Building Manager: [Anthony Conrath, anthony.conrath@oregonstate.edu](mailto:anthony.conrath@oregonstate.edu)  
 Assessment Date: 7/12/2022  
 Assessment Number: **10583**  
 Location: Reser Stadium Entire  
 Reinspection date:

A joint fire safety inspection of the facility listed above was performed by the Environmental Health & Safety - Fire and Life Safety and the Corvallis Fire Department. These fire safety deficiencies could result in a fire or jeopardize the safety of those occupying the facility. Please see that these items are corrected immediately and no later than the scheduled reinspection date noted with this report. If you have any questions regarding this inspection, please email Brian Lilley (EH&S - Fire and Life Safety) at [brian.lilley@oregonstate.edu](mailto:brian.lilley@oregonstate.edu).

Room 430

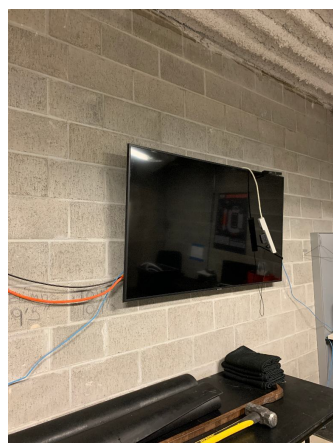
2	All sprinkler valves shall be supervised/locked in the open position, accessible, and unobstructed. Door to control room shall be identified.	2019 OFC 901.4.6.1 and 903.3.8.4	430:entrance	DEPT	Provide "CONTROL VALVE" sticker for door into room 430.	
---	---	----------------------------------	--------------	------	---	--
